Re: Hunters Pond POADP # 657

The City Staff Development Review Committee has reviewed the Hunters Pond Subdivision Preliminary Overall Area Development Plan # 657. Please find enclosed a signed copy for your files. Although your plan was accepted, please note the following:

PRELIMINARY OVERALL AREA DEVELOPMENT PLAN OF HUNTER'S POND

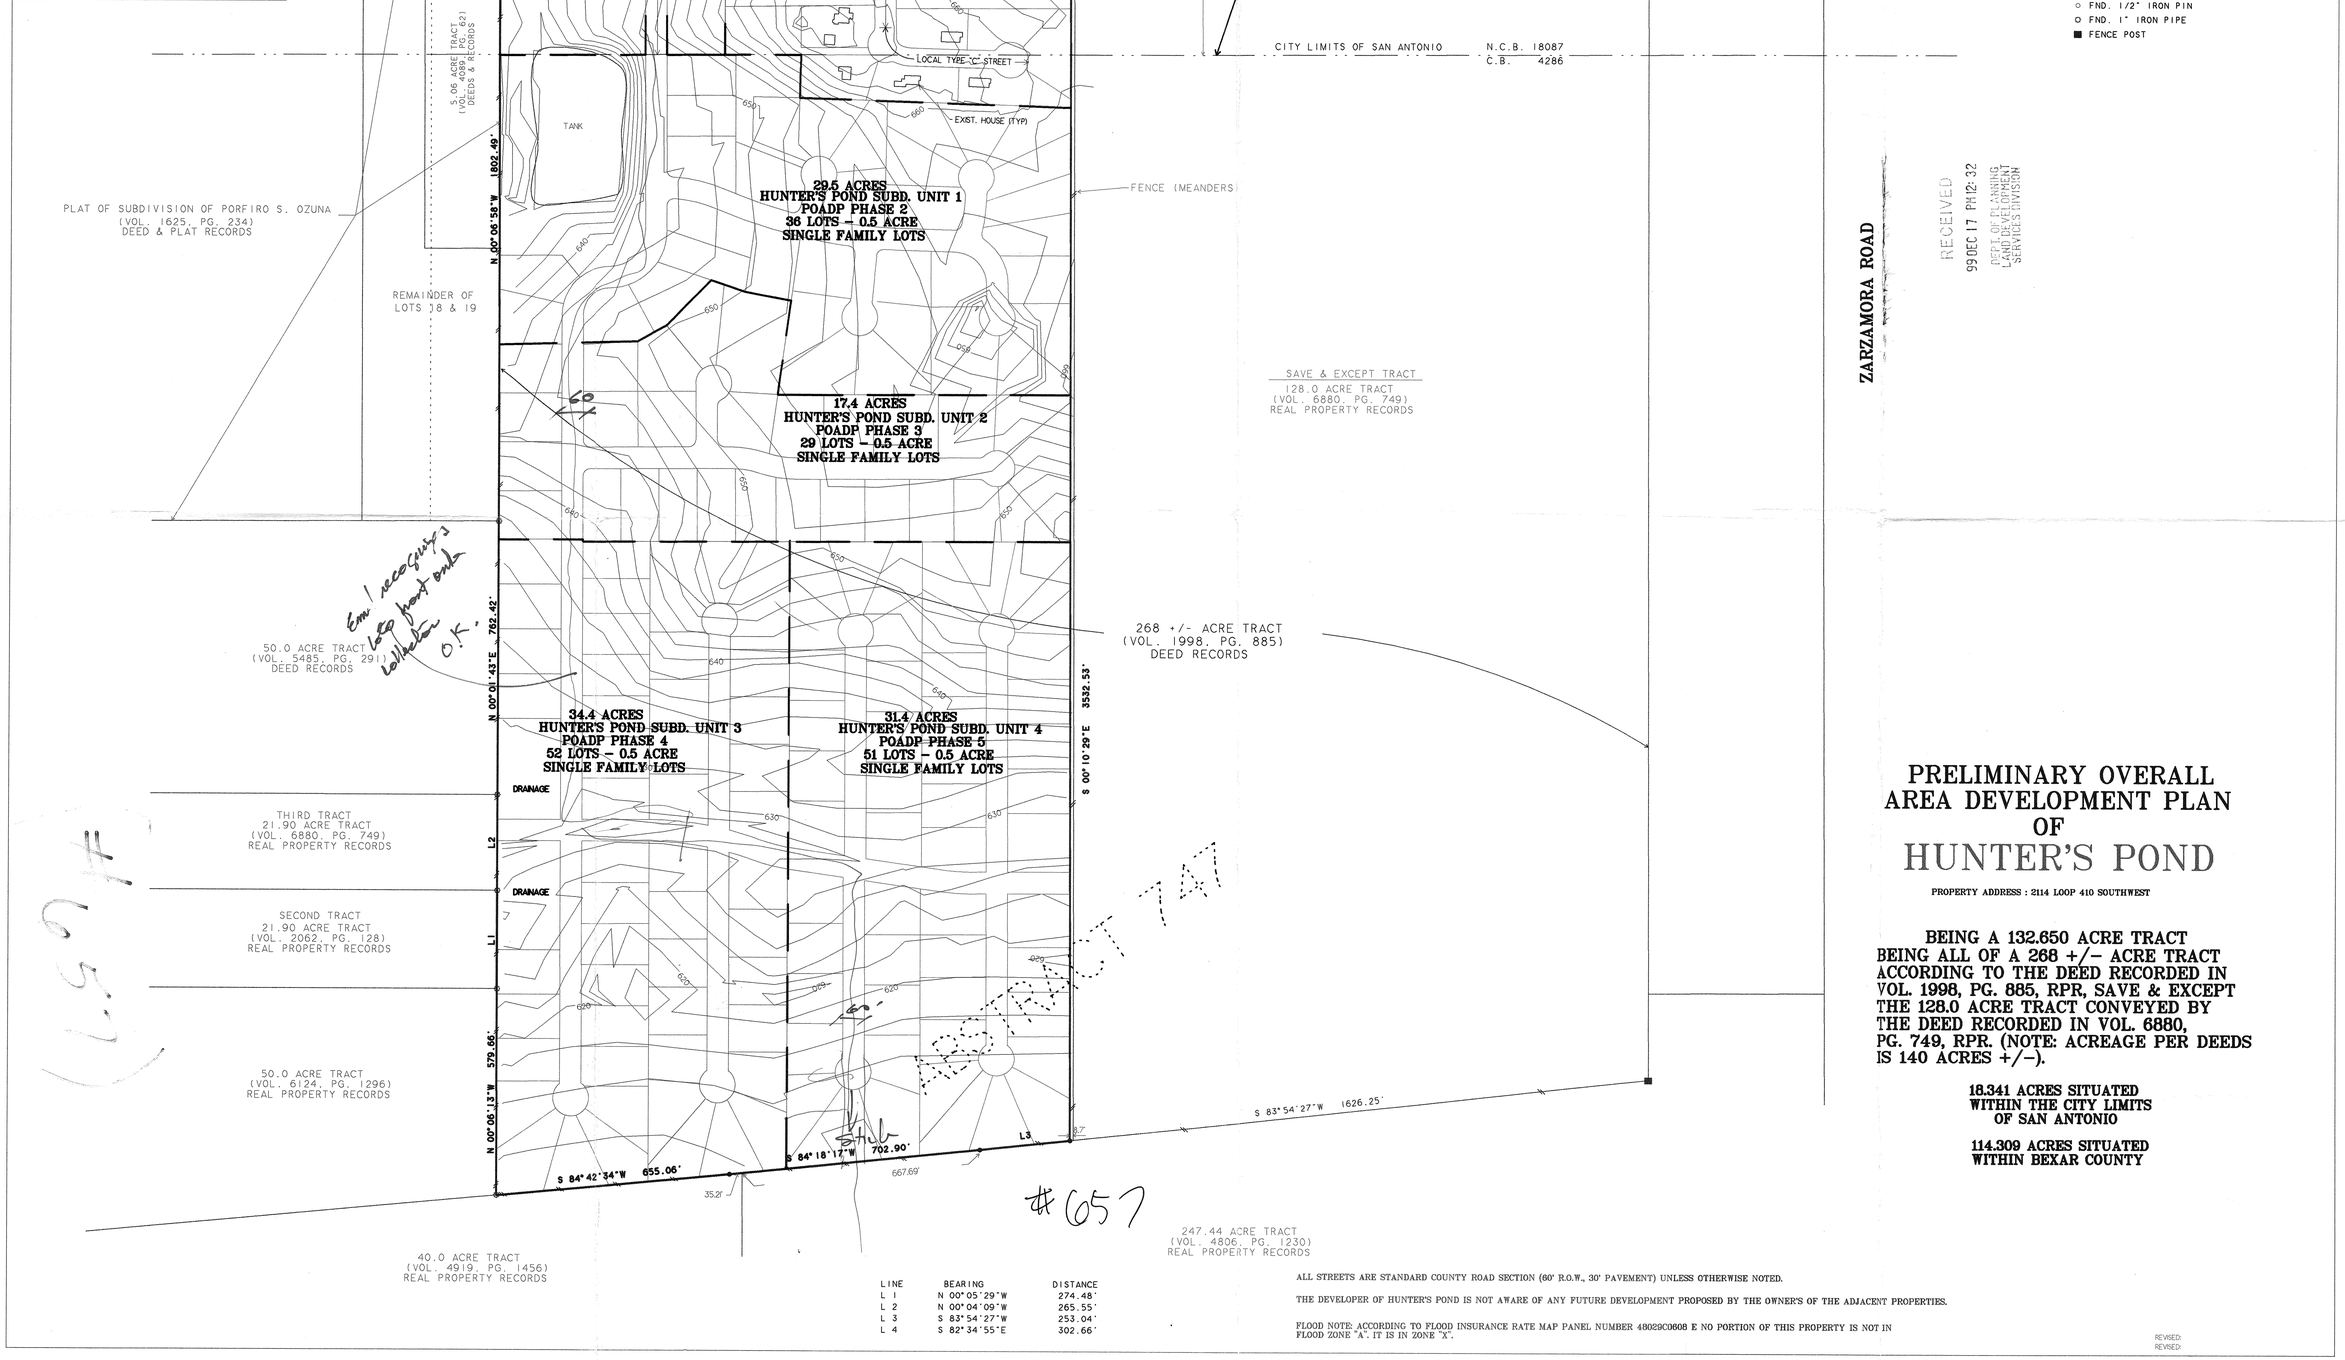
- Based on the topography, a Flood Plain Study and drainage review will probably be required during the platting process. Bexar Co. Public Works will require base flood elevations at the plat level.

- In consideration of public safety and convenience, excessive grades by reason of topography should be avoided in street layouts and arrangements.

- Access and R.O.W. issues along State facilities will need to be resolved with the Texas Department of Transportation (TXDOT). For information about these requirements you can contact TXDOT at 615-5814.

- This development may need to comply with tree preservation ordinance #85262. For information about these requirements you can contact Building Inspections at 207-7102.

- It will be expected that you will plat all of the property depicted in your POADP, to include: floodpains, drainage areas and open space.

- I would encourage you to work closely with the school district, so that they can plan accordingly.
